MEMORANDUM

To: Water Right Files 65-11272A, 65-12423, 65-12656, 65-22552 and 65-22553

Re: Change of Ownership

Claim No(s): 65-07446,
65-12423 + 65-11272A

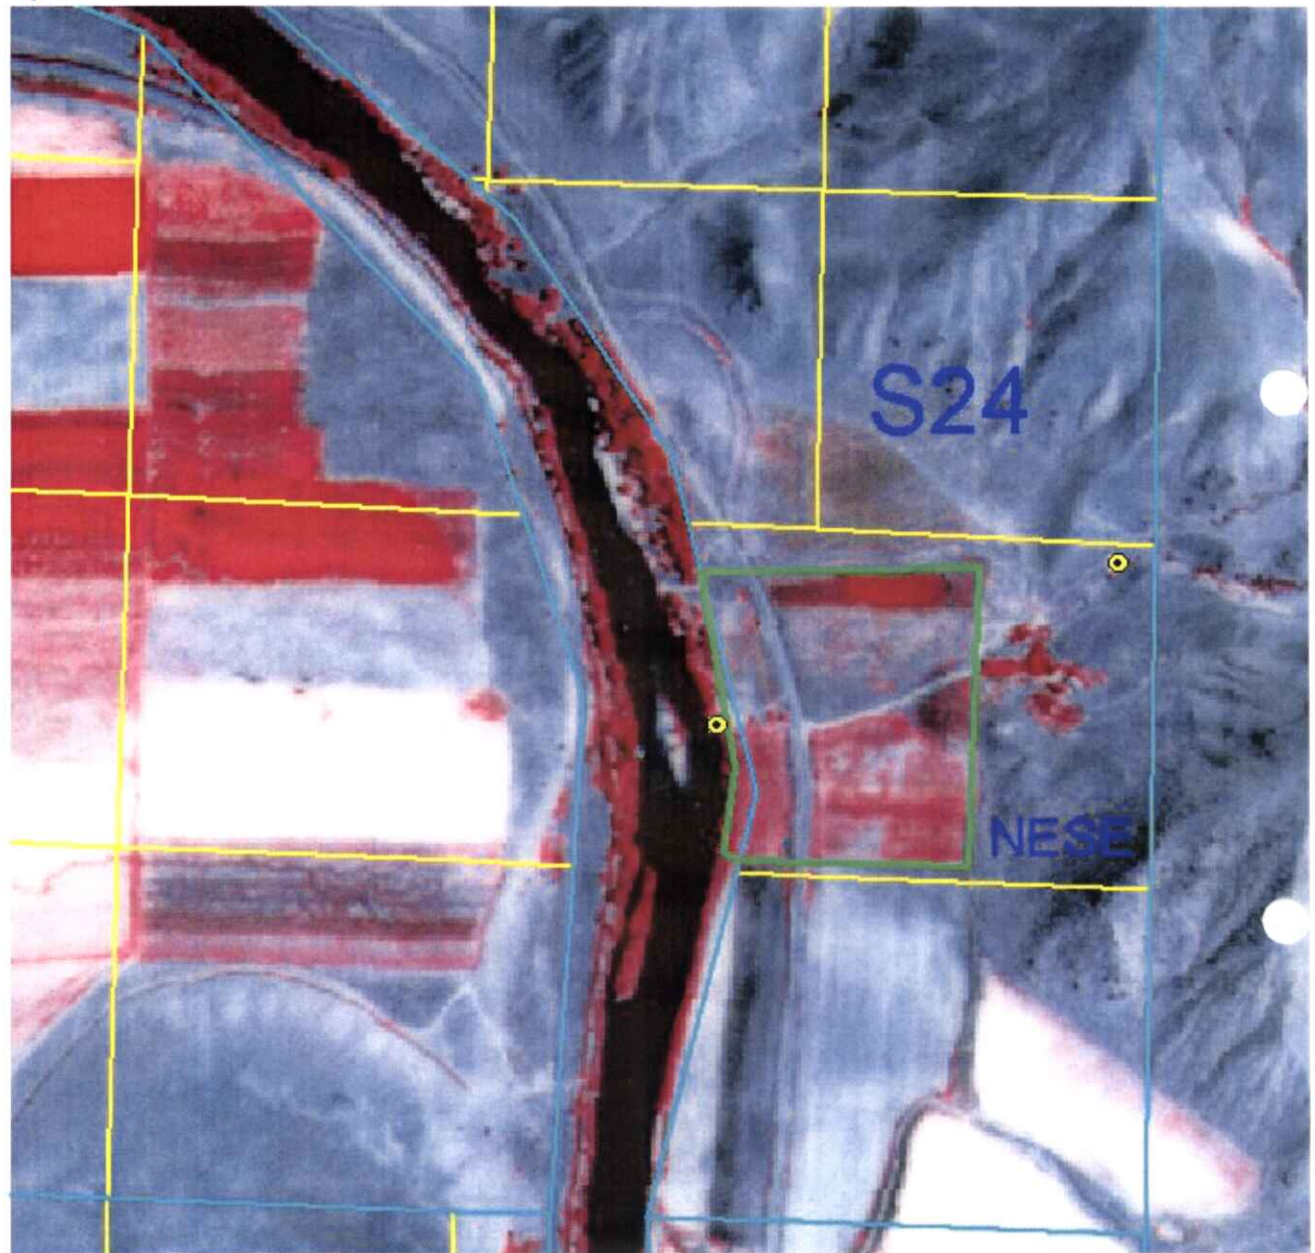
Review of the decrees found that the SRBA shape created for 65-7446, 65-11272A and 65-12423 is a boundary of all three rights together (see attached), but the rights were not decreed as a PPU. Since the ownership change is only for a portion of the overall boundary, review of the historical POU for each right was necessary to determine the ownership splits. Right 65-7446 was split previously based on an ownership change and decreed as split (65-22552 and 65-22553). Right 65-22553 was changed to William and Linda Holstein and the remainder was left in the name of William and Marilyn Shobel (see attachments).

The place of use for 65-11272A and 65-12423 are not part of the parcel owned by Intermountain (see attachments). These rights will not be changed and a refund will be sent to Intermountain for the fees. Proper shapes will be created in SDE based on Payette Decree findings since these rights were decreed in the SRBA the same as Payette Decree and there were no accomplished transfers or PPU. Field exams indicate that these rights overlap right 65-7446.

Claim No: 65-22552

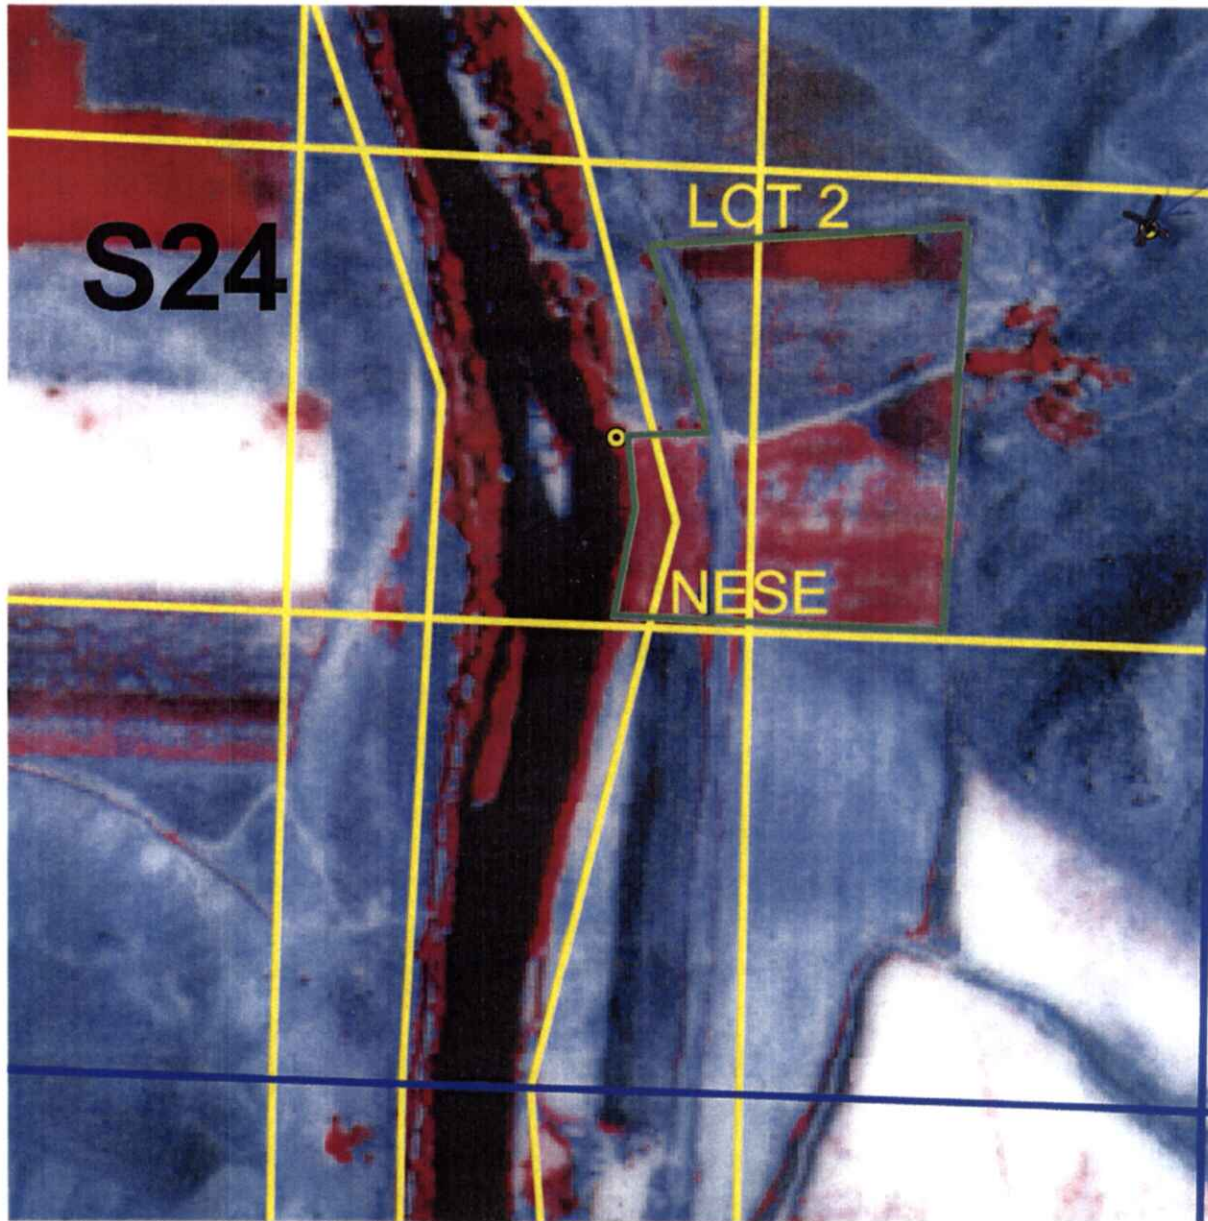
The ownership change to Intermountain Management Group Inc. was processed separately for right 65-22553 on March 23, 2005. Unfortunately, the change was made in error because the parcel owned by Intermountain is just south of the parcel owned by Holstein. Right 65-22553 will be changed back to Holstein. Right 65-22552 will need to be split for a portion in the name of Intermountain (about 1.5 acres).

INCORRECT
POD HIGHLIGHTED
NOT DESIGNED

Claim No: 65-22553

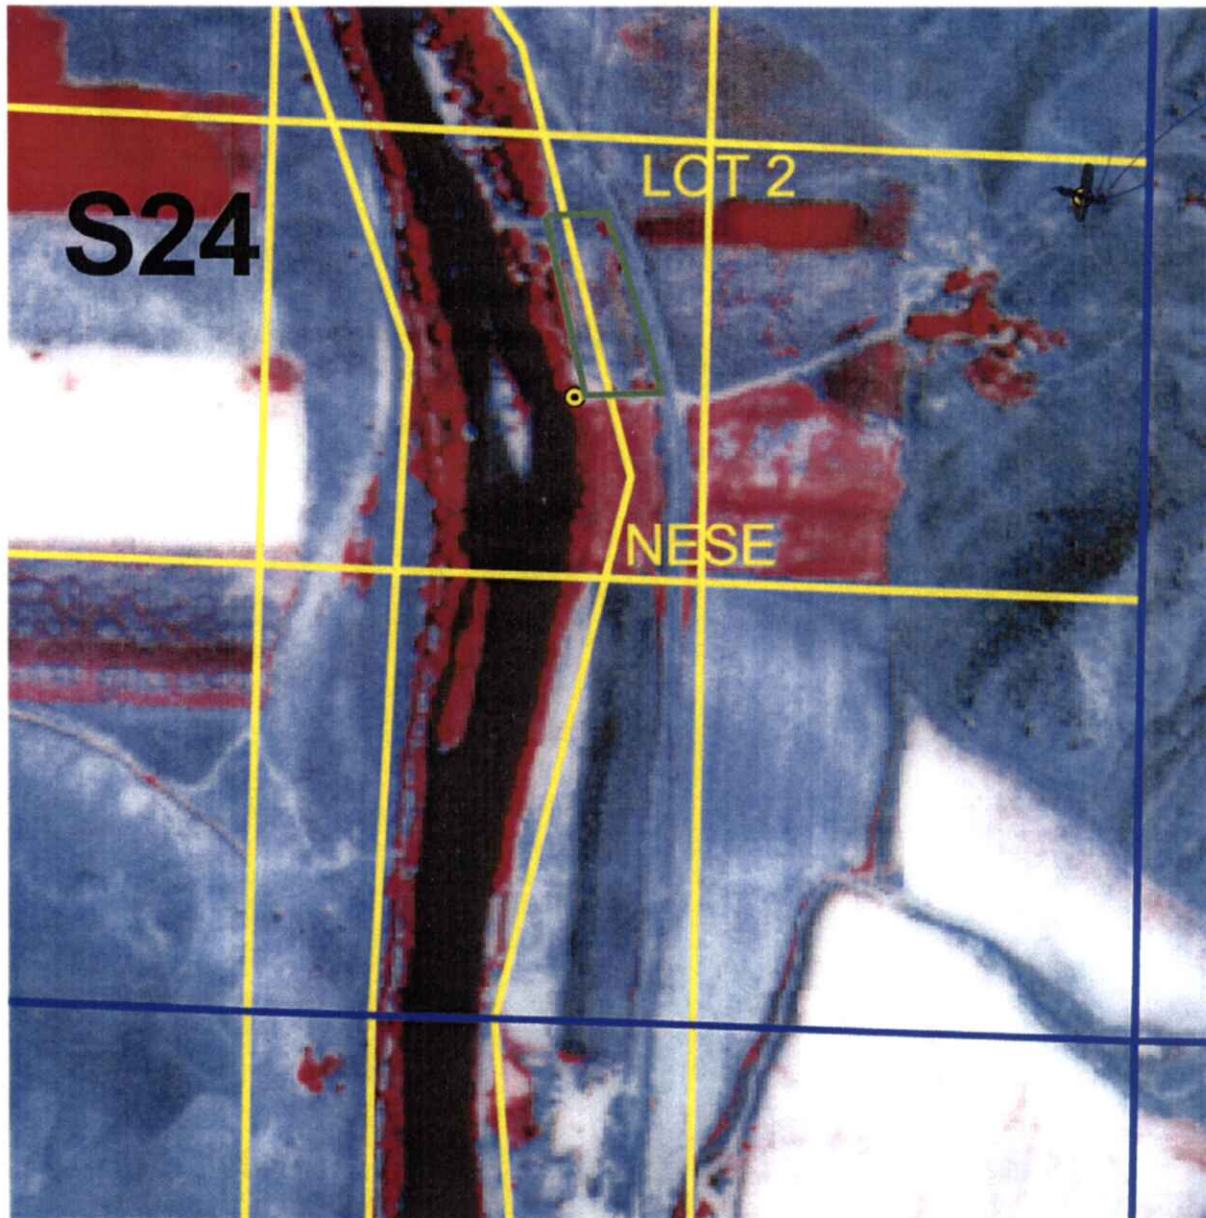
*INCONVERTED
POD HIGHLIGHTED
NOT DISCLOSED*

From xrim 65-12656

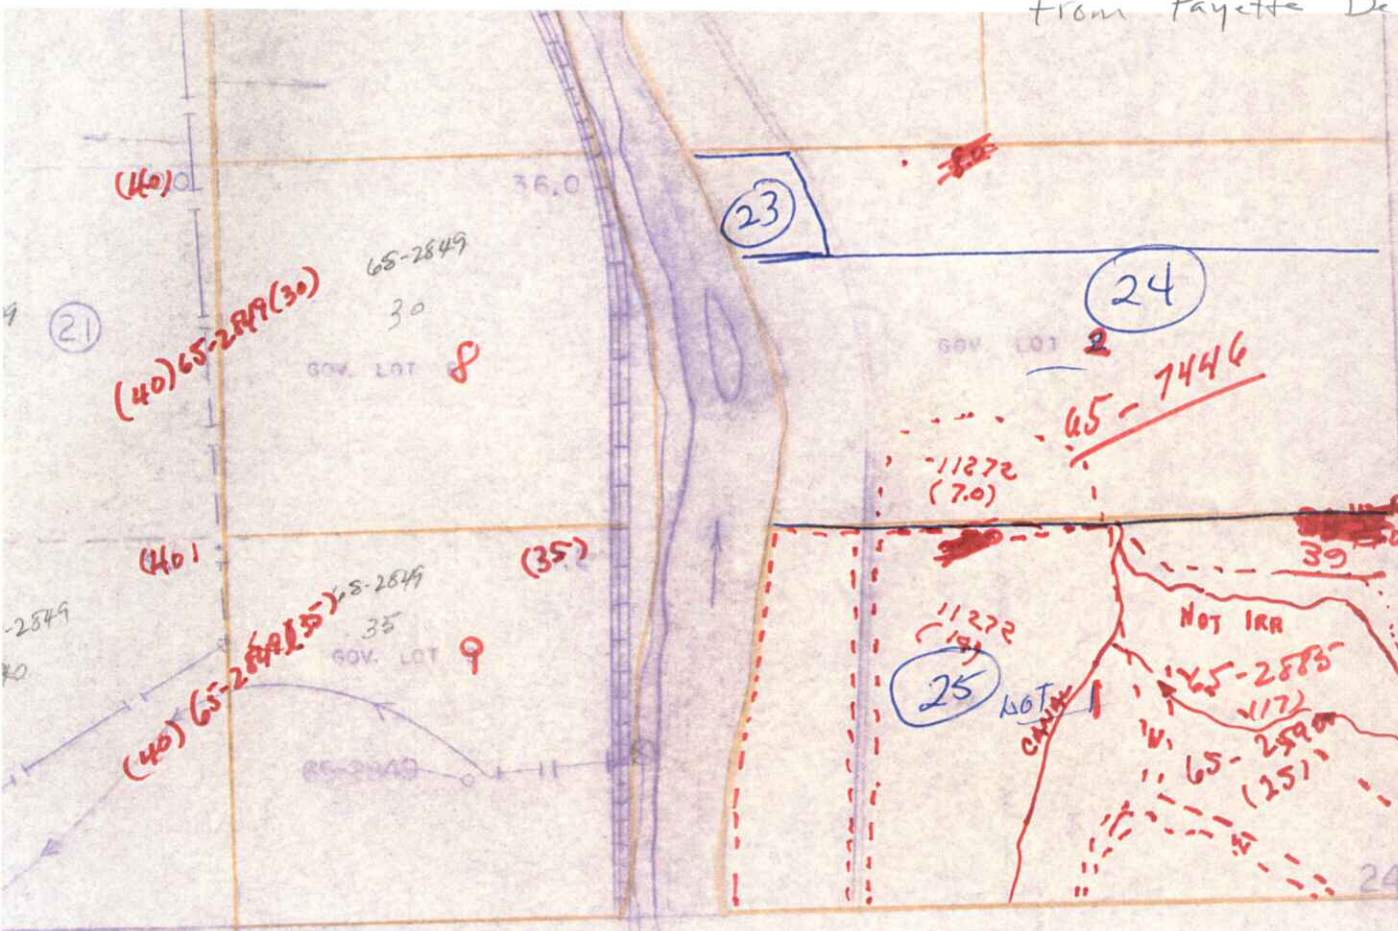
License 65-12656 did not have an accurate shape file in SDE. The field exams maps for 65-7446 and 65-12656 show the historical development of the rights (see attachments). However, the exam map for 65-12656 is not correct for the areas between the river and the highway. Right 65-7446 showed a total of 3 acres (about 1.5 acres each for two parcels) and right 65-12656 showed a total of 4.5 acres (3 acres for the south parcel and 1.5 acres for the north parcel). This would indicate that the south parcel increased by 1.5 acres during the development of 65-12656 (1987 NAPP imagery appears to confirm this, see attachment). A shape file will be created for license 65-12656 to show the licensed acres. A 1.5 acre portion will be split from 65-12656 for Intermountain.

note:
65-12656(15)
provided
1.5 acres
in this
area.

From Exam 65-7446

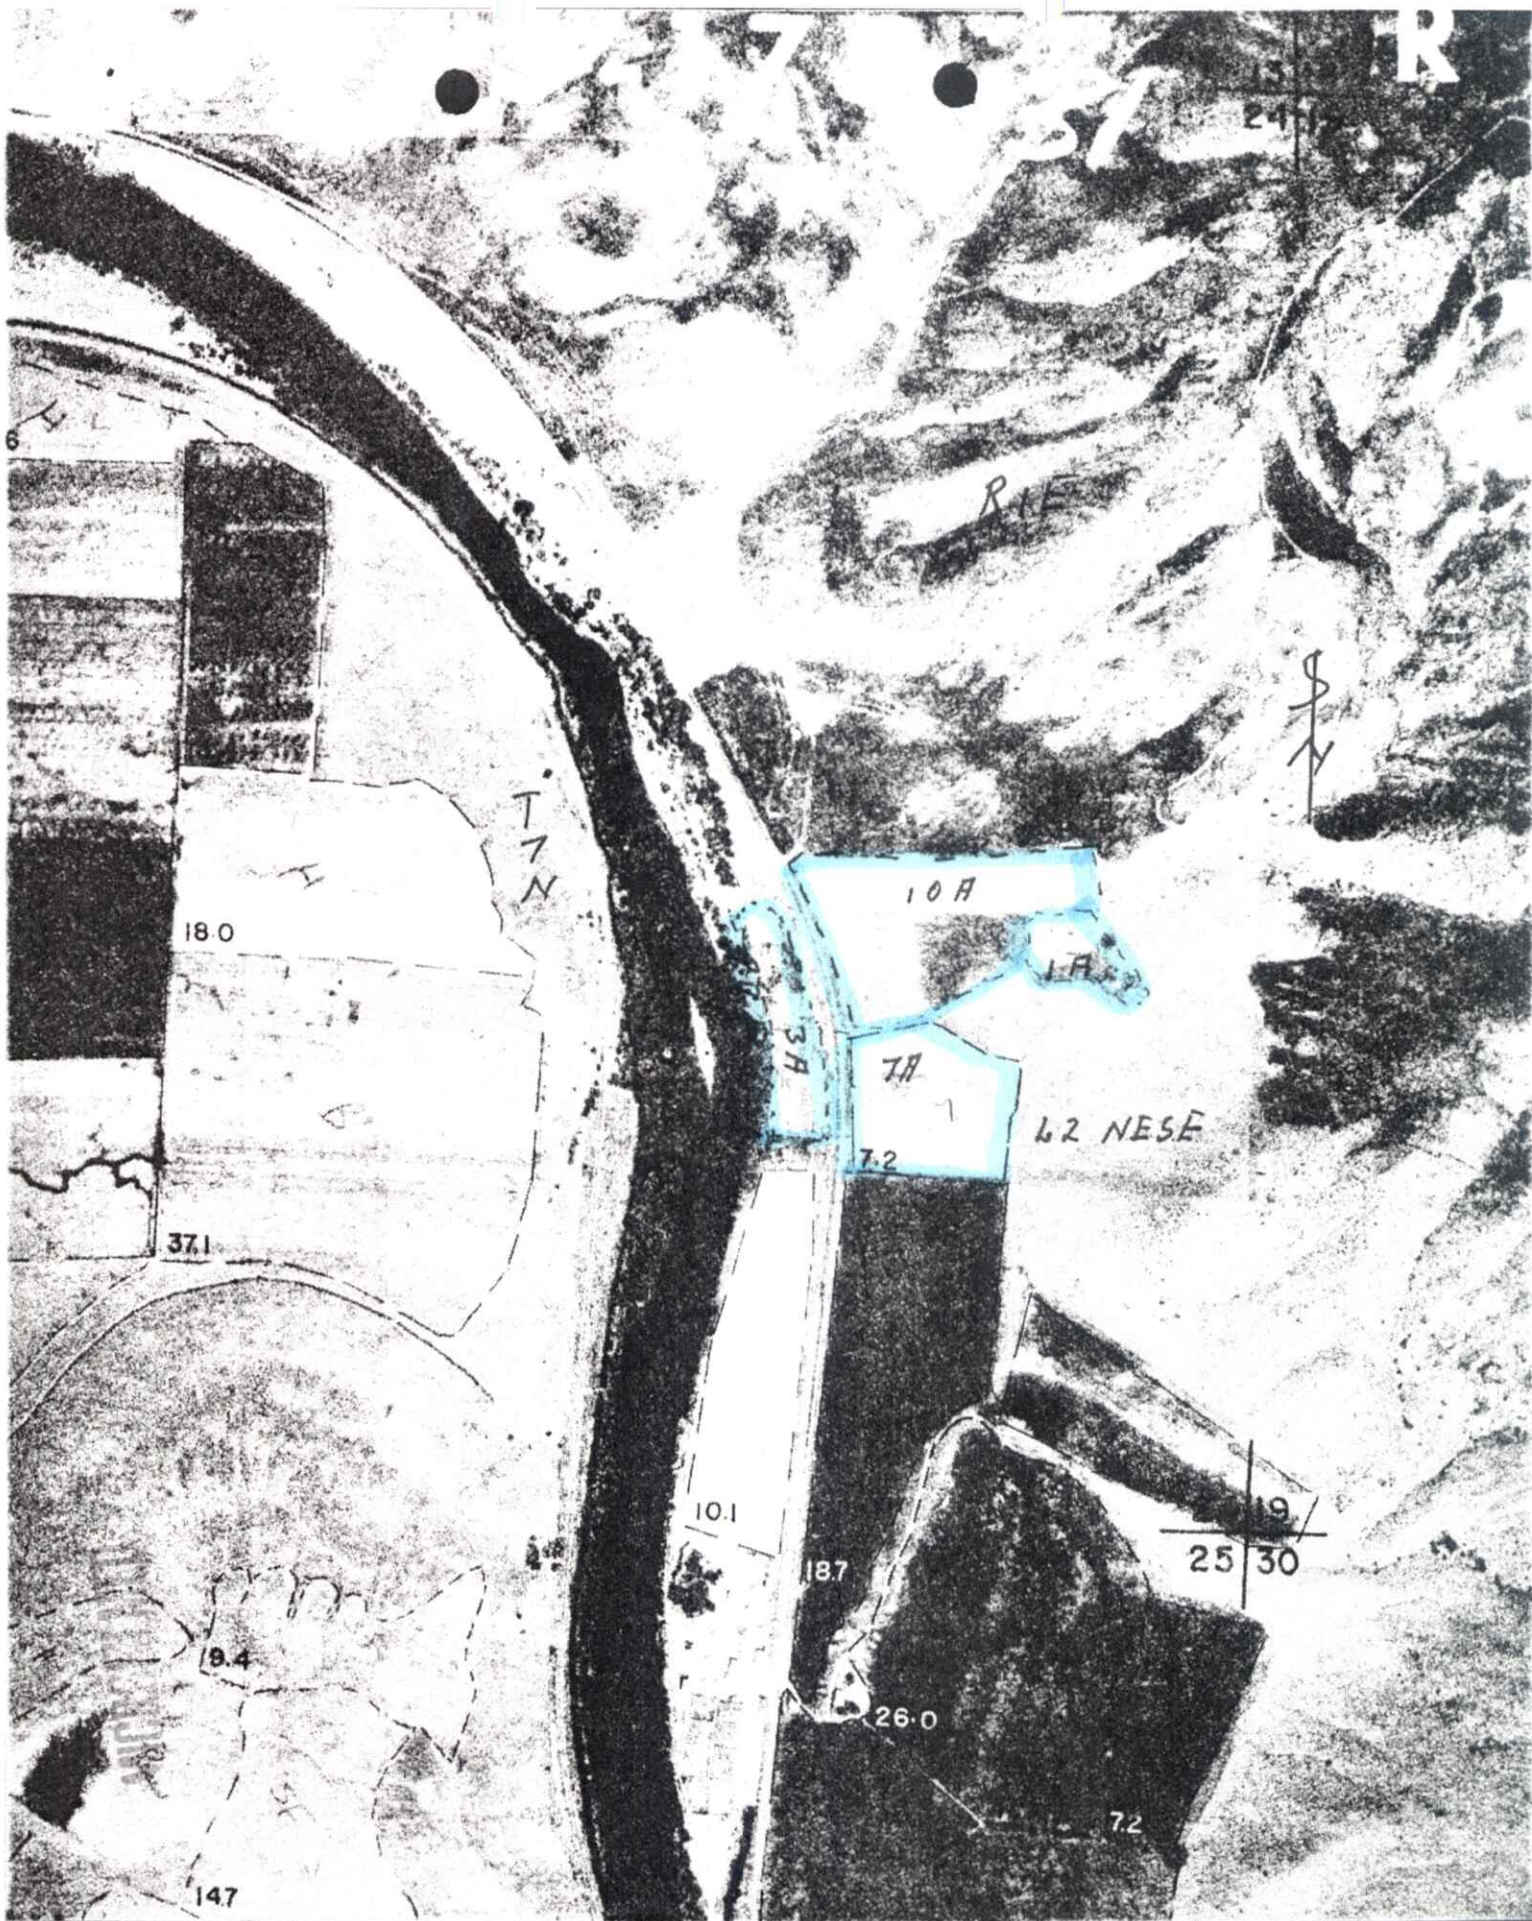
note: Looks like
area between river
and highway increased
between 79 + 87
flights (South 1/2)
under 65-12656

- 3 acres were covered
on N + S portions
under 65-7446
(1.5 acres each)
- South portion
increased by 1.5 acres
under 65-12656
